Subject: N192208640 - Service Update
Engine Runs Rough, Stall, No Restart Due To Damaged Ground
Terminal

Models: 2019 Chevrolet Blazer

N192208640 Engine Runs Rough, Stall, No Restart Due To Damaged Ground Terminal

5271337

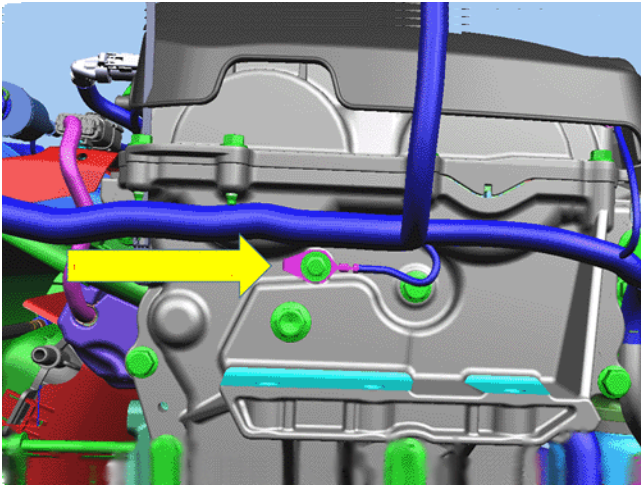
1. Open the vehicle hood and locate the G113 ground terminal ring on the right (passenger) side of the engine.
2. Verify the correct installation of the ground terminal ring to the engine. A mechanics mirror may help obtain a better view.

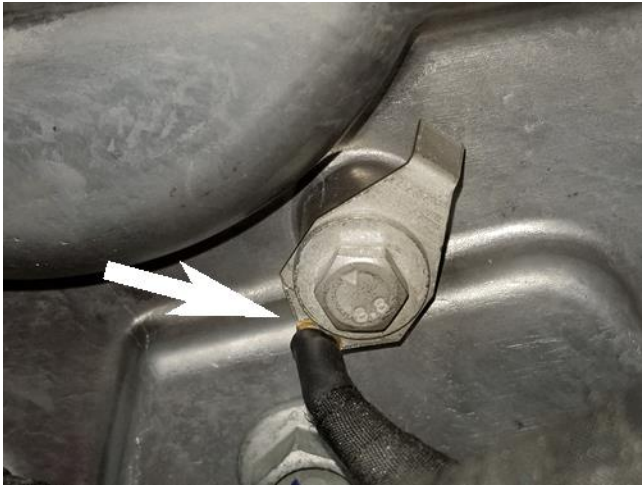
- If the tab on the ground terminal is positioned toward the rear of the engine compartment (as shown), no further action is required.

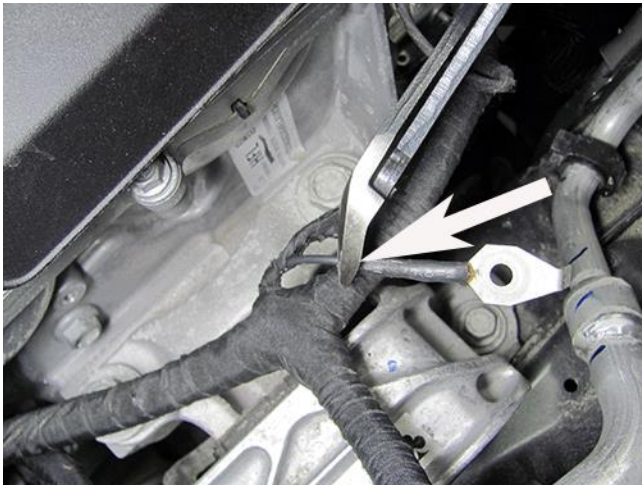
- If the ground ring tab is rotated in a different direction, the wire connection on the ring is bent or there appears to be a strain on the wire, proceed to step number 3.
3. Remove the air cleaner assembly. Refer to *Air Cleaner Assembly Replacement* in SI.
 4. Unbolt the G113 ground terminal ring from the engine.
 5. Unwrap the harness tape from the G113 branch.

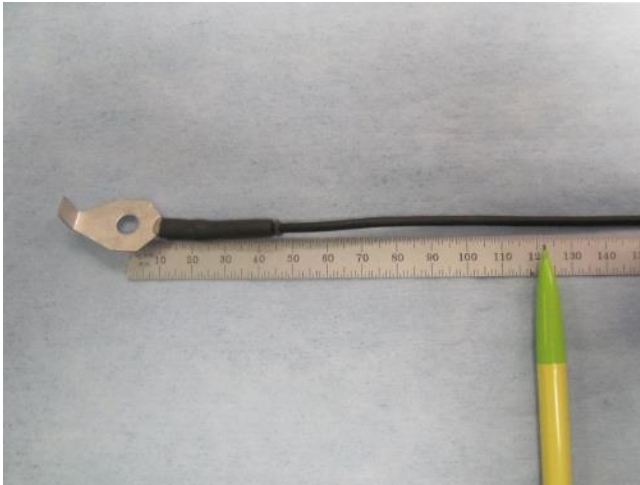
6. Locate the end of the shrink tube on the ground terminal, cut the wire at this location. Discard the old ground terminal.

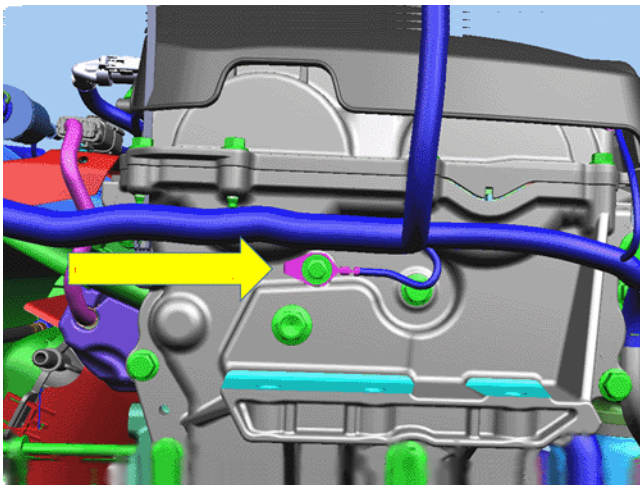
7. Prepare the service terminal kit wire length. Measure 123mm. (4.85in.) from the center of the bolt hole in the ground terminal, cut to length.
8. Install the new terminal kit. Refer to *Wire to Wire Repair* in SI.

9. Rewrap the harness branch as necessary.
